COAL MINING AND RECLAMATION PERMIT APPLICATION TO REVISE A PERMIT (ARP)

Permit Number: D-1159
Application Number R-1159-6

ARP Type:
Add Sump

ADDENDUM TO A.R.P., ITEM 4
AMERICAN ENERGY CORPORATION
PERMIT D-1159

SUMP PLAN VIEW
(NOT TO SCALE)

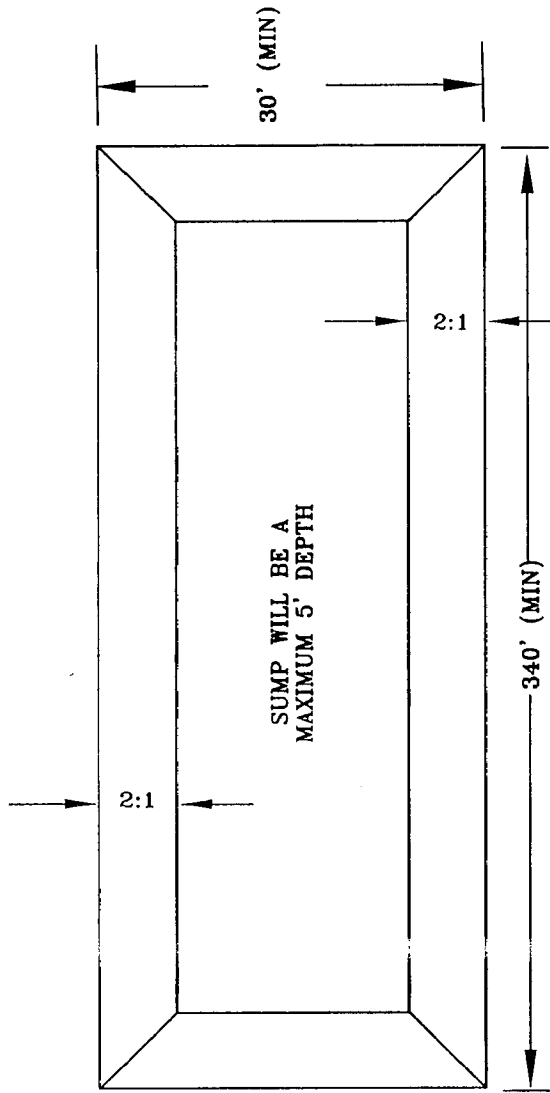
3. Section of mining and reclamation plan to be revised:
PART 3, PAGE 30, ITEM H.(4)
4. Describe in detail the proposed revision and submit any necessary drawings, plans, maps, etc.:
THIS PROPOSED REVISION IS TO INSTALL A SUMP IN THE FORMER LOCATION OF POND 018 AND ELIMINATE POND 018 FROM THE PLAN AS SPECIFIED IN APPROVED A.R.P. R-1159-2. SEE ATTACHED ADDENDUM. DISCHARGE FROM THE SUMP WILL FLOW TO POND 018A.

5. Describe in detail the reason for requesting the revision:
A SUMP IS A MORE APPROPRIATE CONTROL STRUCTURE FOR THIS LOCATION BASED ON SITE SPECIFIC CONDITIONS AND THE CURRENT MINING PLAN.
